APPLICATION NO.	FILING DATE	FIRST NAMED INVENTOR	ATTORNEY DOCKET NO.	CONFIRMATION NO.
09/941,655	08/30/2001	Hiroshi Kanazawa	381KA/50358	7423

# Office Action Summary

**FIG. 3**

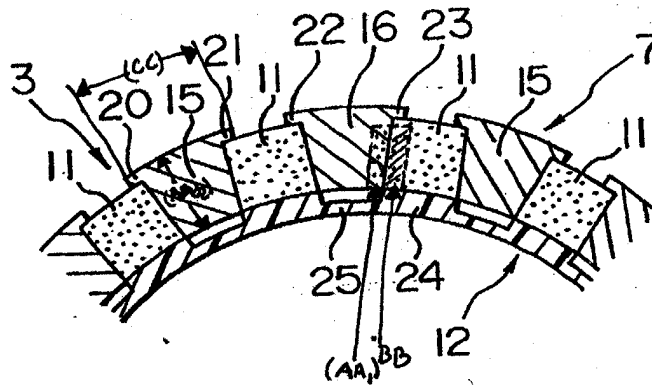
Kusase et al. discloses in Figure 1 a rotating electric machine in which a rotor (3), stator (2) are functioned by a stator coil (5) over a stator core (4), with the rotor having a pair of claw-type magnetic poles (15 and 16) placed in alternative directions and in contact with the whole of the magnetic pole surface of the permanent magnet. A permanent magnet (11) is placed close to a pair of claw-type magnetic poles with the field coils (8) placed radially internally within the claw-type magnetic poles. Kusase et al., further illustrates in Figure 3, the auxiliary magnetic pole portion (AA) in contact with the whole of the magnetic pole surface (BB) of the permanent magnet (11), with the auxiliary magnetic pole portion has a greater width (CC) in the radial outer side of the rotor than the inner side. The inner surface (DD) of the claws in the radial direction of the rotor is parallel to an outer surface of the rotor, with the claws (15) interconnected by a ring-shape member (25); in addition the claws have a magnet holding portion (AA).

Further more, Figure 8 discloses a protective covering (PC) on the radial direction of the outer side of the permanent magnet.
